Crete Nursery, Dappers Lane, Angmering, West Sussex

Arboricultural Method Statement ADDENDUM

Produced on behalf of Countyoak Homes Ltd on
13/11/2019

Site Reference: EE-19-10250-01

Plate 2: Garden & Boundary Fences

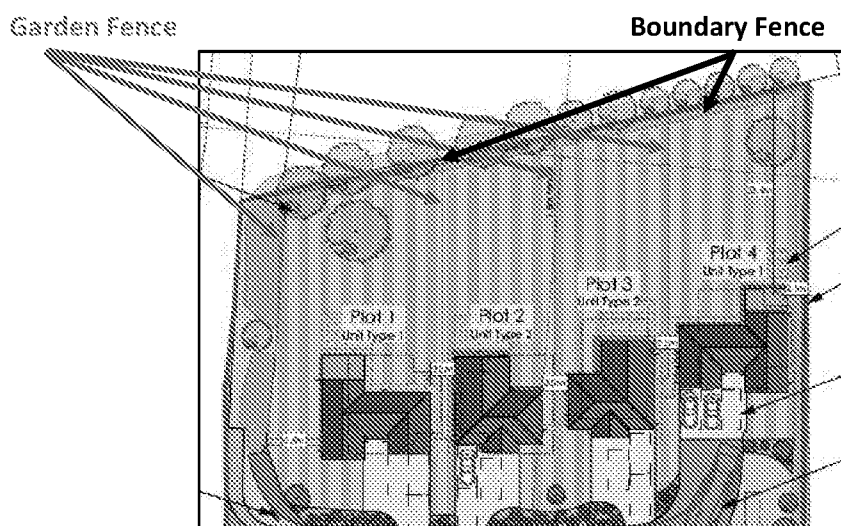
- 1.4 Paragraph 3 states *'The AMS does not cover in enough detail what is happening with the boundary fencing and garden division fencing within the RPA of the hornbeam trees to the north and off-site – mitigation measures and methodology required here.'*

- 2.2 The development proposals require the construction of small fences (1.8m high) to delineate the gardens of each plot and the northern boundary of the site (see Plate 2). The boundary and garden fence will be comprised of closeboard panels and posts, the posts will require digging within the RPA of the hornbeams.

- 2.3 There is an existing wooden fence that demarcates the northern boundary of the site (refer to Plate 2 & Plate 3). The holes left by the removal of the existing fence posts will be used to erect the new fence posts. It is not known how deep these currently go however it likely that they will have been sunk to a depth of 0.30m or more. The height of the new fence will be 1.8m and the fence posts will be sunk to a depth of 0.5m, requiring extra digging of c. 0.2m.

- 2.4 The garden fence (see Plate 2) will be constructed using 1.8-metre-wide panels with supporting fence posts. This will require digging a maximum of three fence posts per fence line to be dug within the RPA of the line of hornbeam to the north of the site. The holes for the fence posts will measure L: 0.2m x W: 0.2m x D: 0.5m – the holes will be lined with a series of plastic sheets to ensure damaging leachate from the concrete block base does not enter the RPA of the hornbeams.

- 2.6 Within the RPA, the holes for fence posts will be dug using hand tools only; specific fence digging equipment is appropriate.
- 2.7 The depth of the holes for the fence posts will measure 0.5m deep and 0.2m x 0.2m wide. The fence post will be held in place using either post mix or ballast and cement.

- 2.8 The erection of each post, from digging the hole to setting the post, will be completed in one go to avoid having roots exposed overnight.
- 2.9 The boundary fence will be placed over the existing wooden fence that marks the northern boundary of the site using the location of existing posts as the support network for the new fence.

- 2.10 The holes for the fence posts will be lined with a series of plastic sheets to ensure damaging leachate from the concrete block base does not enter the RPA of the hornbeams. The series of plastic sheets will be comprised of an initial layer of thin sticky plastic, akin to carpet protector, that will be rolled around the outside of the hole to create an impermeable layer. Two narrow sheets of thicker polythene sheeting will then be laid in a crisscross fashion over the bottom of the fence post as it is inserted into the hole to create extra protection from leachate and to ensure the thinner outer layer is not perforated in the act of inserting the fence post.

Plate 4: RPA of T07 in Relation to the Existing Hardstanding Access Track
Dominant Category A Oak Tree (T07) With 9.15m RPA Superimposed

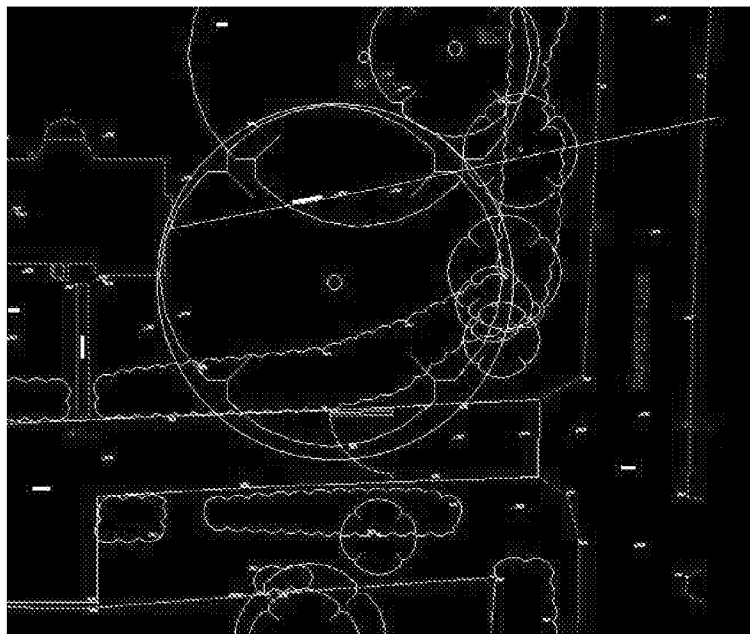
- 1.5 Paragraph 4 states that *'The AMS does not detail exactly what is happening and the mitigation measures and methodology required here for any revisions to the access drive (widening or resurfacing) that appear to be taking place.'*

- 3.1 The existing access road will be resurfaced and replaced with a permeable hardstanding access track. The RPA of T07 extends beneath the existing hardstanding track therefore its removal will need to be undertaken under an Arboricultural Method Statement and Arboricultural Watching Brief.

- 3.2 The removal of the existing hardstanding track will be undertaken using the '*break up, pull back*' principle. The pieces of concrete will be taken out by hand and placed outside of the area of concern. The subbase will be taken out using a mini digger stationed on the remaining hardstanding to ensure roots do not become compacted.

- 3.3 The area exposed will be protected and cordoned off, using tree protective fencing (*if necessary*), between the time that the existing hardstanding is removed and the replacement permeable hardstanding is implemented.

- 3.4 A subbase of appropriate depth and durability will be laid underneath the replacement permeable paving to ensure that roots do not become compacted and water can percolate to the roots over the long term.

- 3.5 The southern extent of the replacement road will follow the line of the existing track and will not extend further toward the dominant Category A oak (T07).

- 3.6 The RPA of T07 (9.14m) will be measured and marked-out using fluorescent spray paint, where it extends underneath the existing hardstanding access track, to identify the area of concern to all site users. This will be undertaken at the earliest possible convenience following full planning permission being granted. The marked-out area will conform broadly to that highlighted in the bottom picture of Plate 4. The line will be suitably annotated to clearly signify what it is marking out, the hardstanding outside of this line can be removed without the supervision of an arboricultural watching brief.

- 3.7 The existing hardstanding access track will be removed by breaking apart the concrete using hand tools, such as a pneumatic drill (jackhammer), under the supervision of an arboricultural watching brief. The concrete will be retrieved by hand from the existing hardstanding, where possible, and from scaffold boards laid out to protect roots, where not possible. The pieces of concrete will be placed within the site outside of the contentious areas, the subbase will be removed with a mini digger, from the remaining hardstanding, using the '*pull back*' technique and under supervision of the arboricultural watching brief.

- 3.8 The soil exposed from underneath the removed hardstanding will be covered, using a tarpaulin and weighed down / buffered from weather using sharp sand or another inert granular fill (not builder's sand because of its high salt content) to protect the roots from desiccation and rapid temperature changes. The area will be also be cordoned off using tree protection fence, if necessary, and all site access will be excluded from the area until the construction of the replacement permeable hardstanding access track is started.

- 3.10 What can be stated with confidence is that the levels beneath the subbase of the existing track will not be taken down more than 200mm beneath the existing base of the subbase of the existing access track. Less than 10% of the RPA of T07 extends beneath the existing access track and more than 90% of a tree's roots will be in the top 1.0 metre of soil. If it was necessary to take the soil down to the maximum depth of 200mm, this would constitute a loss of less than 2% of the RPA of T07. Add to this the fact that the replacement access track will be permeable, thereby improving the quality of the soil and the utility of the roots to the tree, the impact of excavating 200mm of soil will be negligible over the short term and neutral over the long term to the amenity of T07.
